CLOVERLEAF SUBDIVISION

PRELIMINARY PLAN

Preliminary Plan_v4.pdf Markup Summary

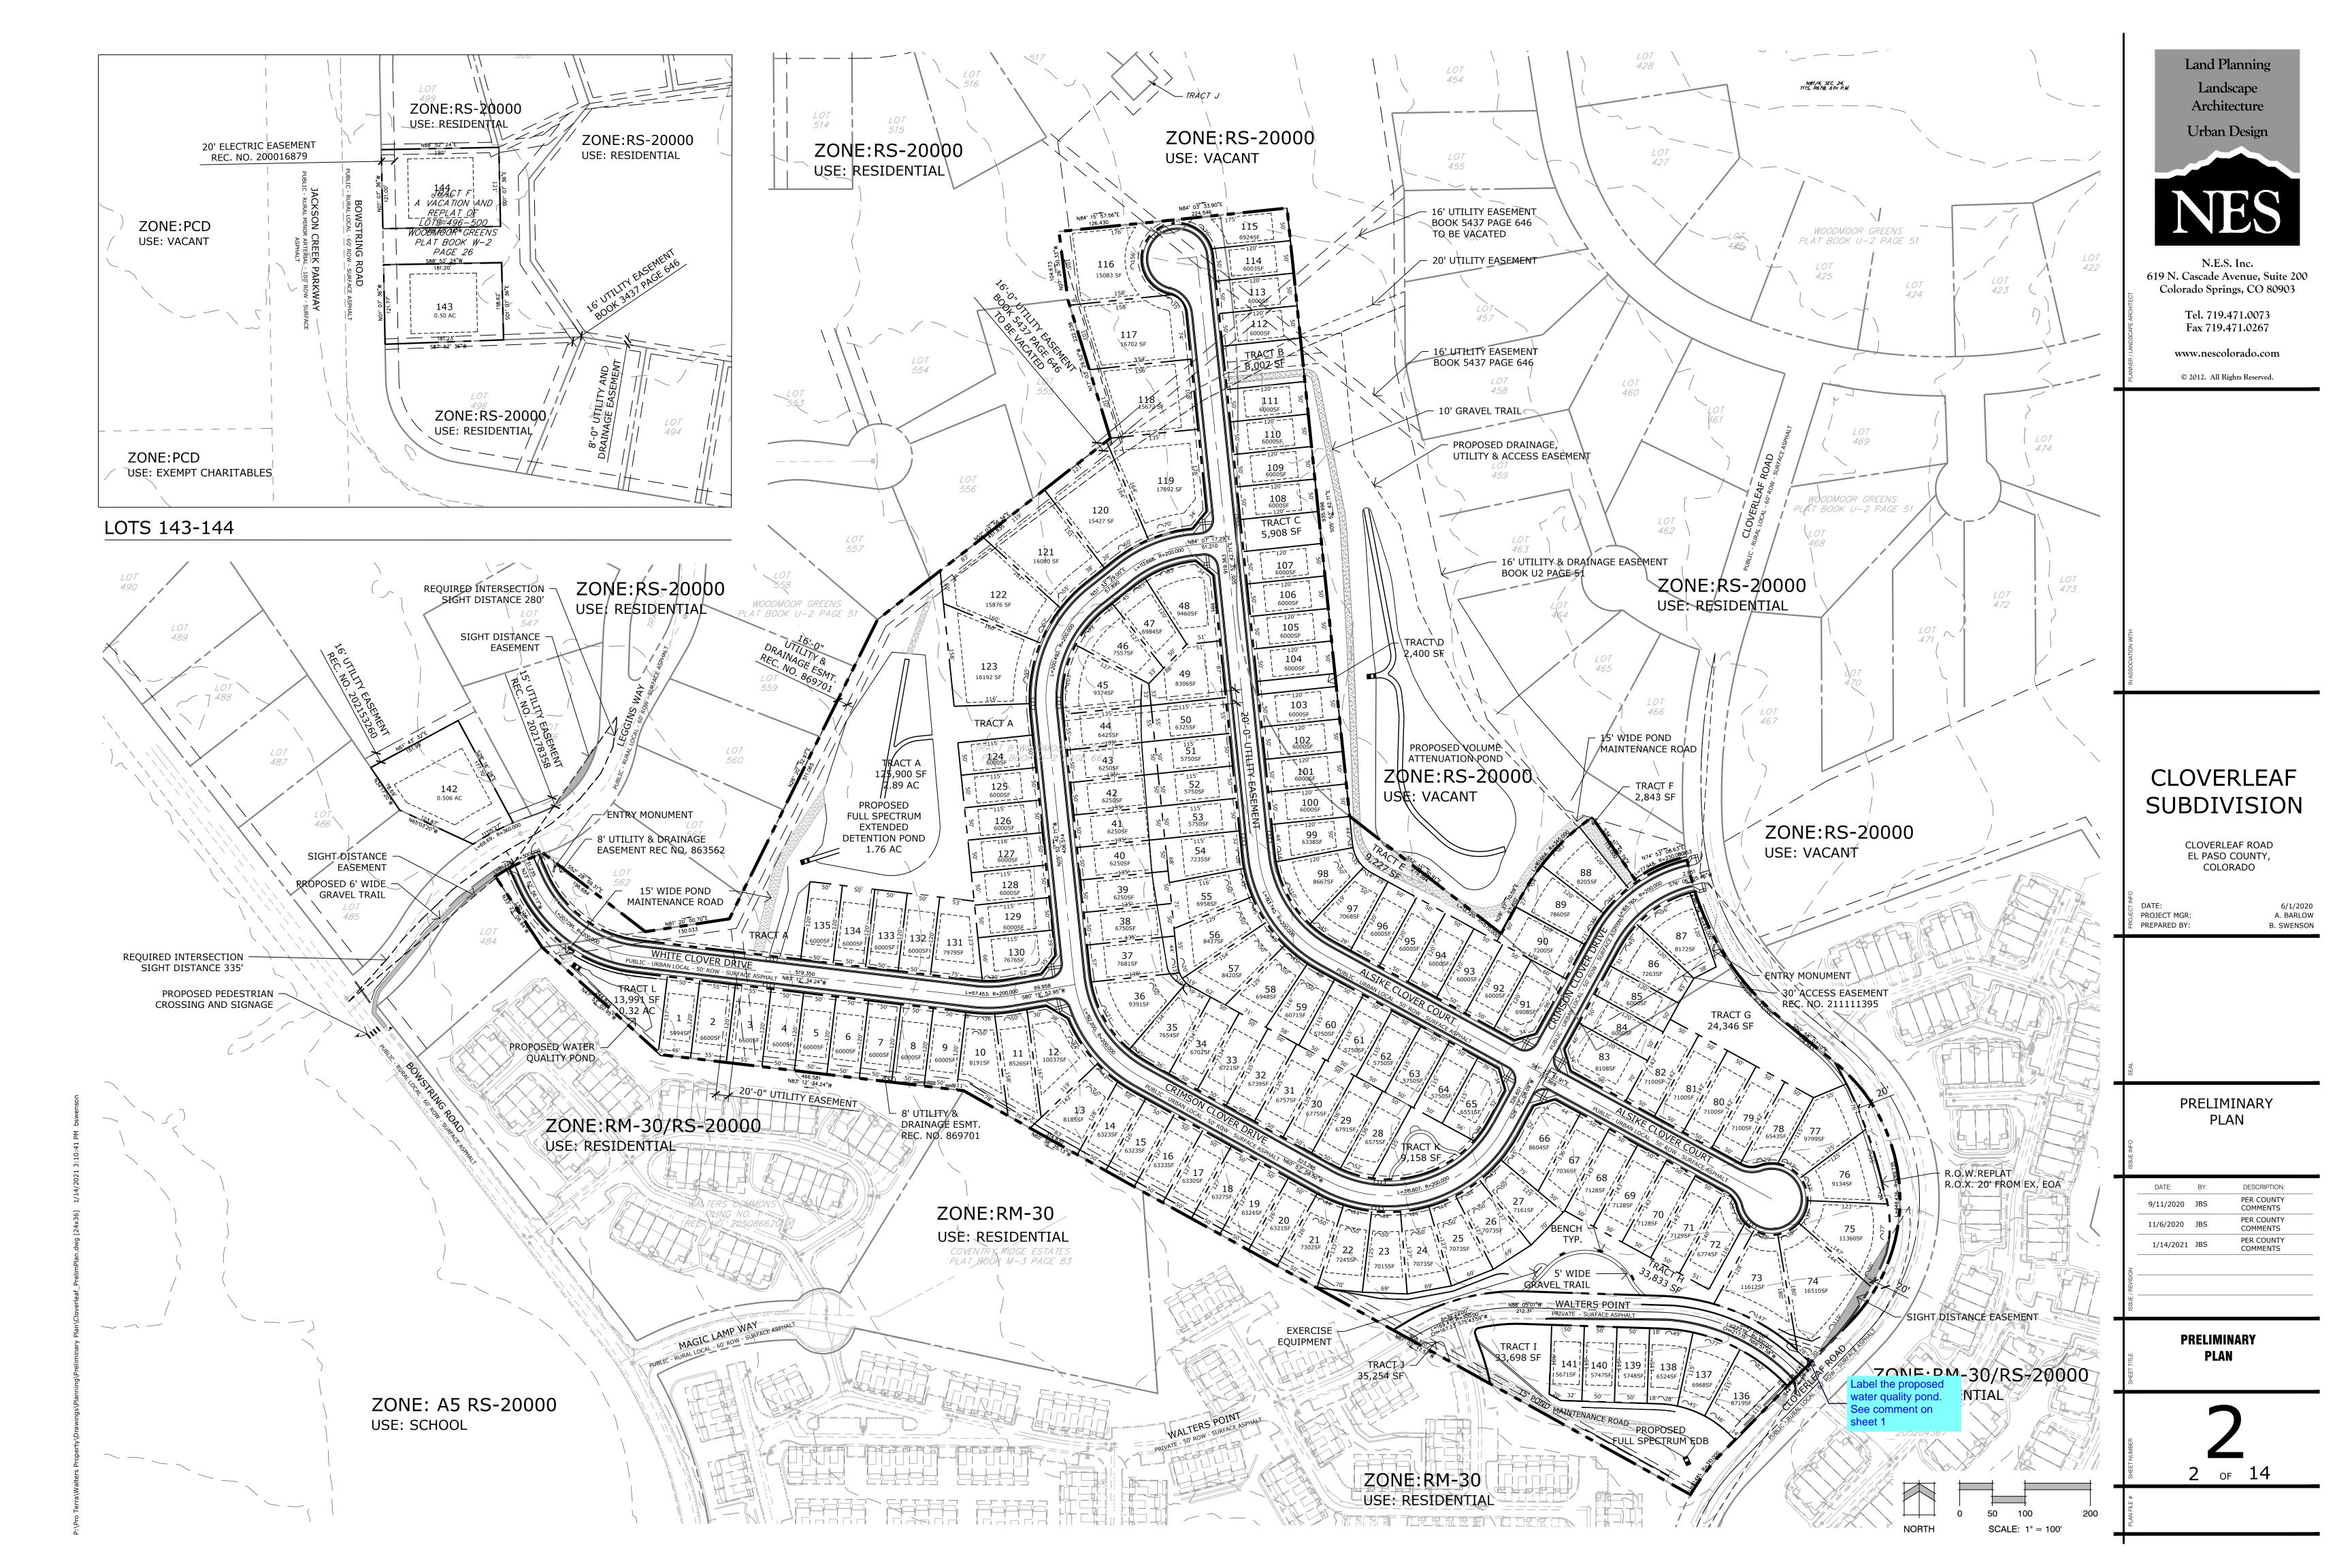
Update to include the water qualit

WQ Pond is proposed in a portion of Fract J, Lot 73 & Lot 74.

Previous comment recommended adjusting lot line so the pond is entirely within Tract J to simplify ownership/maintenance.

> Iltimately plans need to identify this facility and identify who owns/maintains this facility.

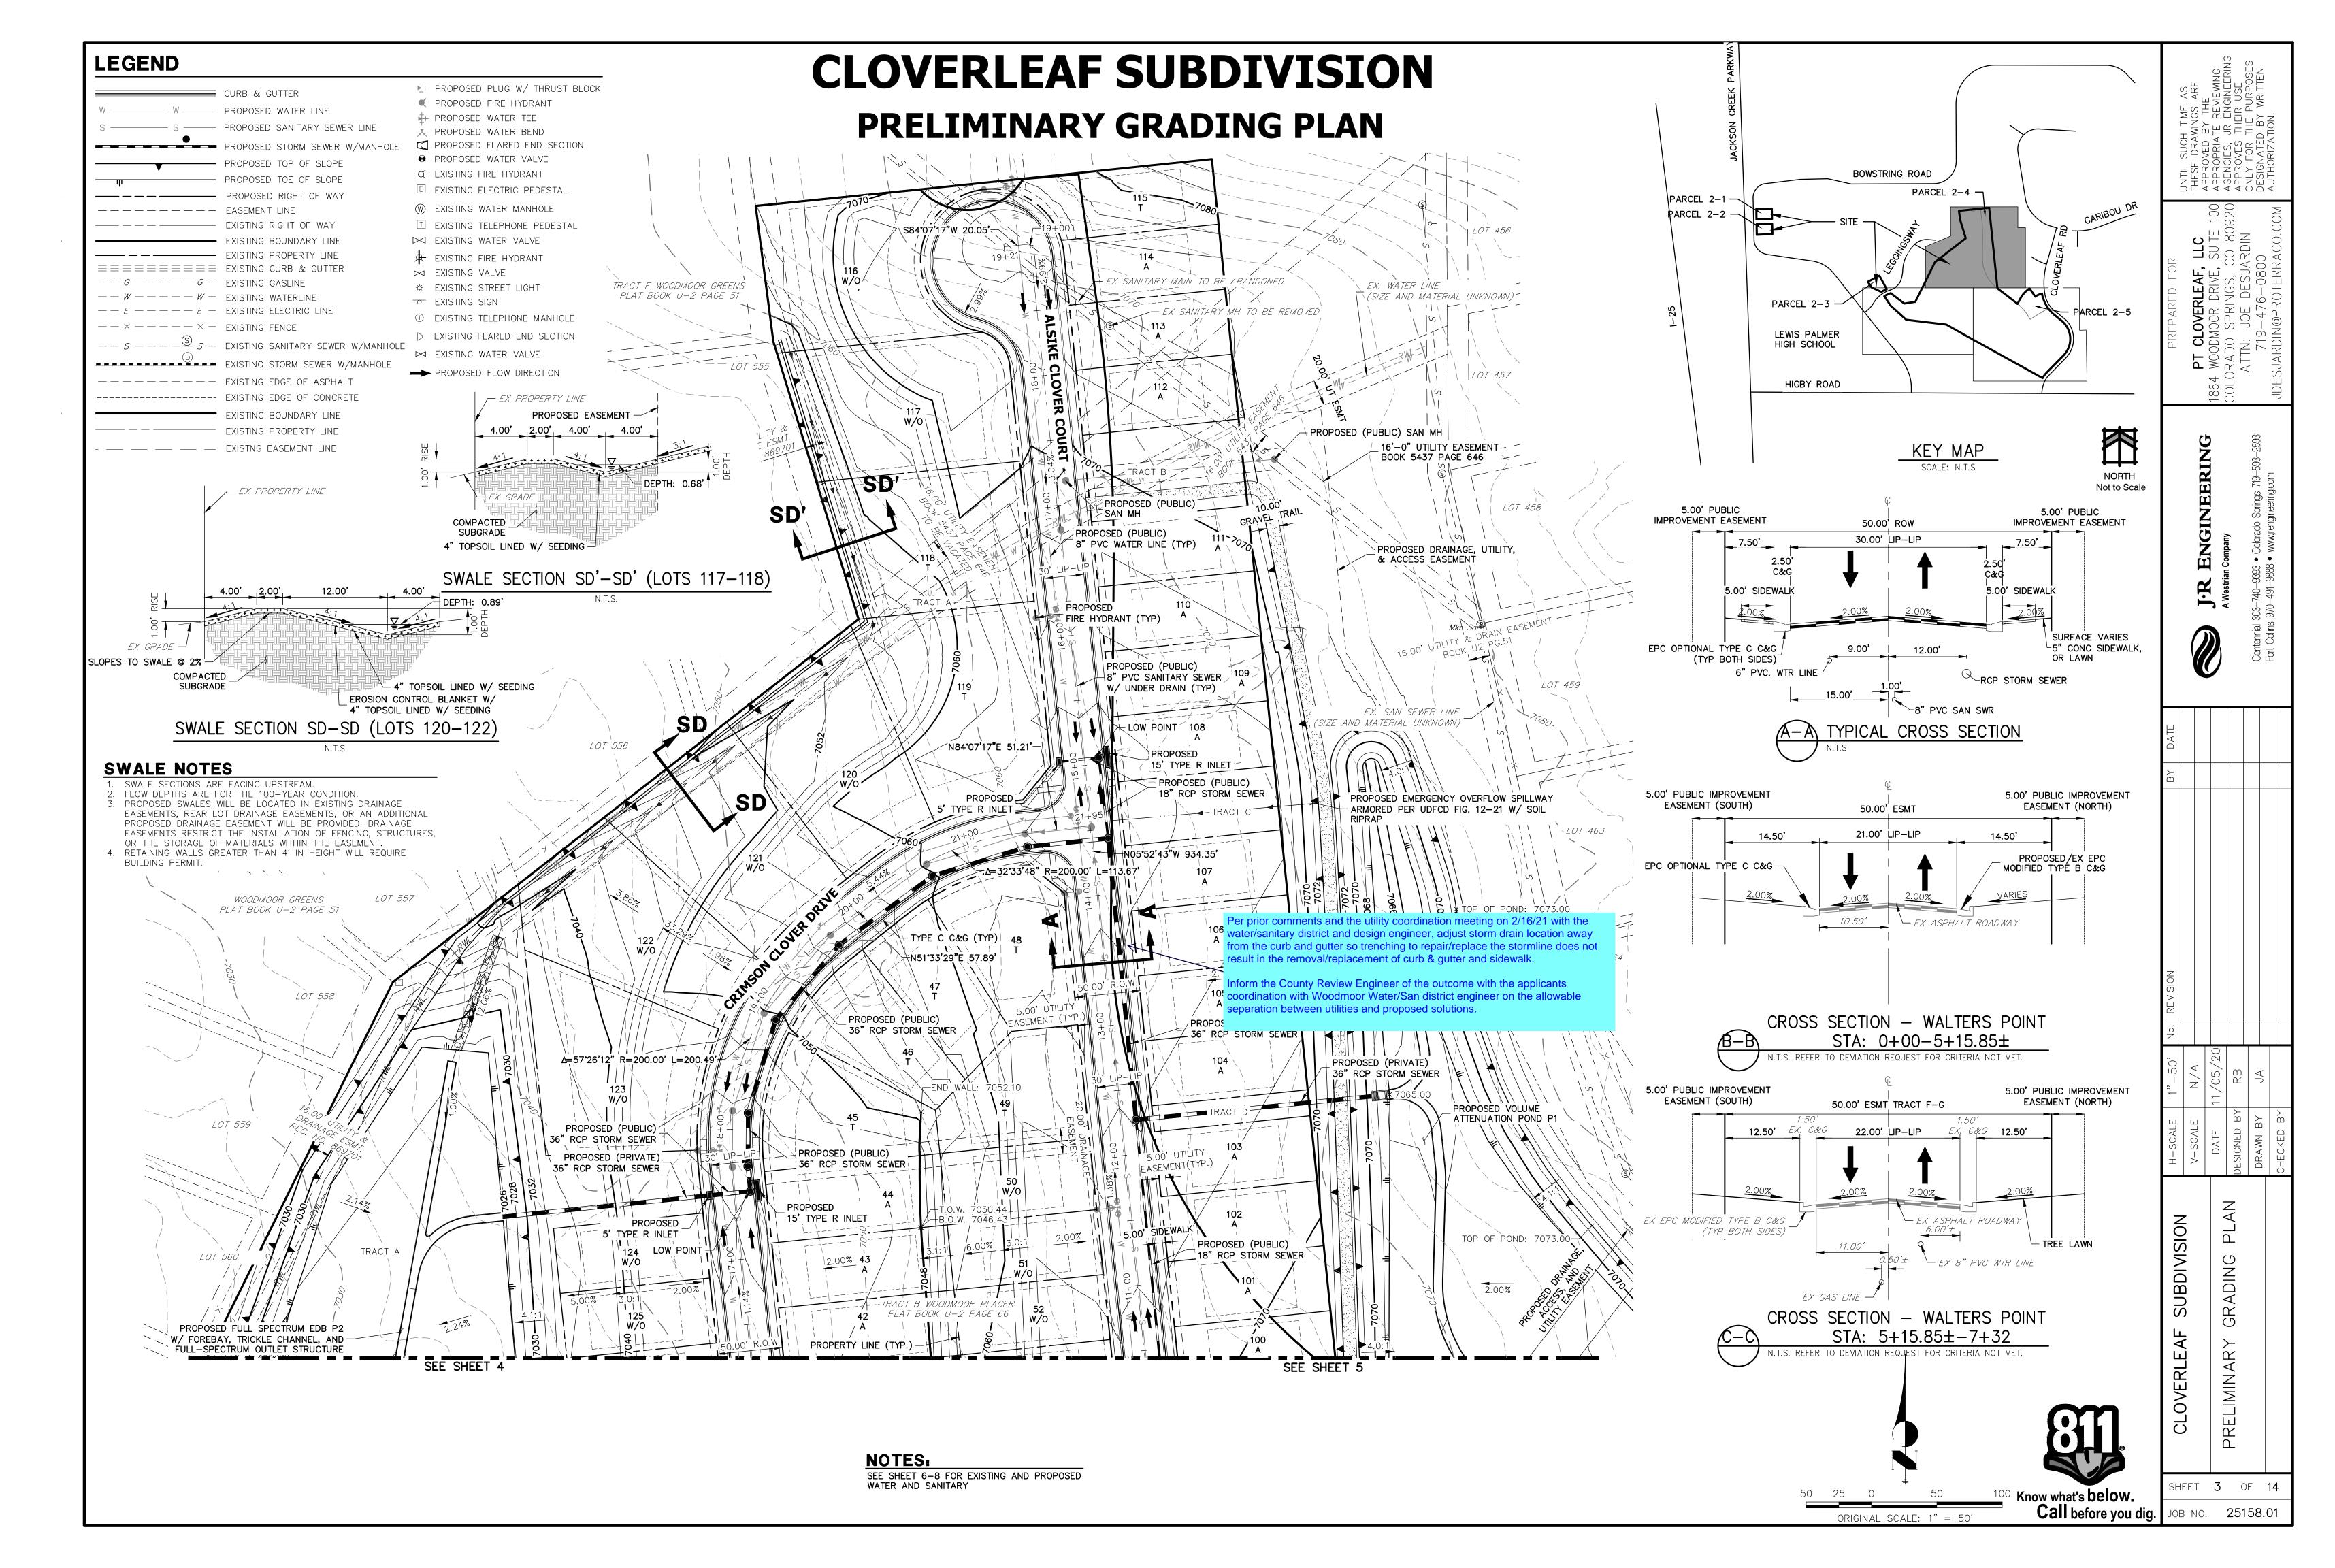
Status: Color: Layer: Space: Label the proposed water quality pond. See comment on sheet 1

CLOVERLEAF SUBDIVISION	DETAILS		
	SHEET	13	OF	14
g.	JOB NO.	2	5158.	.01

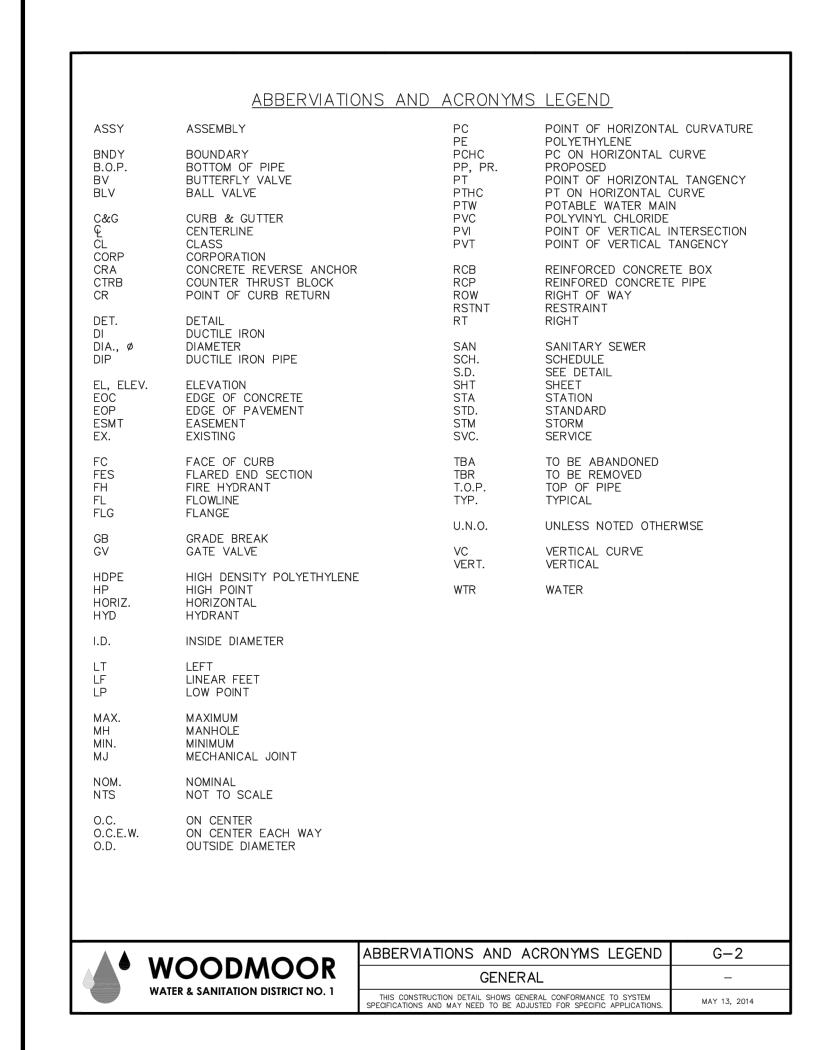
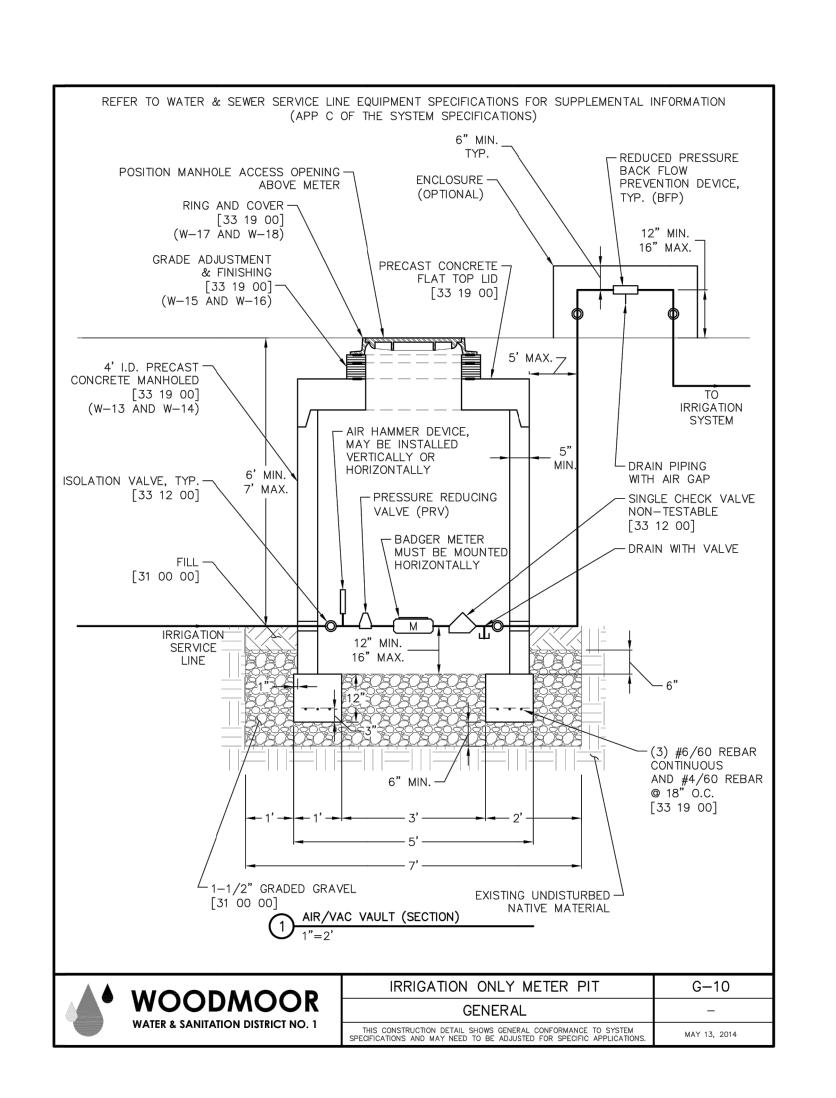
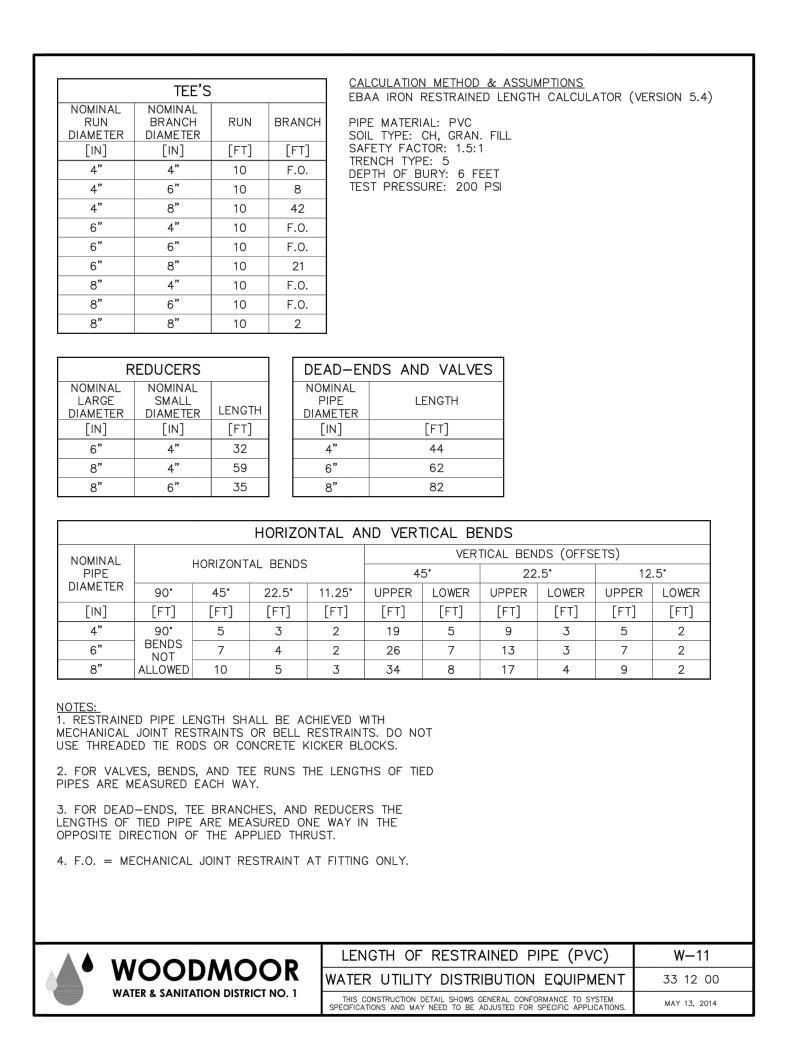
Status: Color: Layer: Space: Per prior comments and the utility coordination meeting on 2/16/21 with the water/sanitary district and design engineer, adjust storm drain location away from the curb and gutter so trenching to repair/replace the stormline does not result in the removal/replacement of curb & gutter and sidewalk.

Inform the County Review Engineer of the outcome with the applicants coordination with Woodmoor Water/San district engineer on the allowable separation between utilities and proposed solutions.

Status: Color: Layer: Space: For Information Only: Per the utility coordination meeting on 2/16/21, staff confirmed that curvilinear pipes is allowed per ECM 3.3.1.F based on pipe manufacturer's recommendation.

Reminder: If redesigned as curvilinear pipe then identify the radius and include the pipe specification showing the recommended radius in
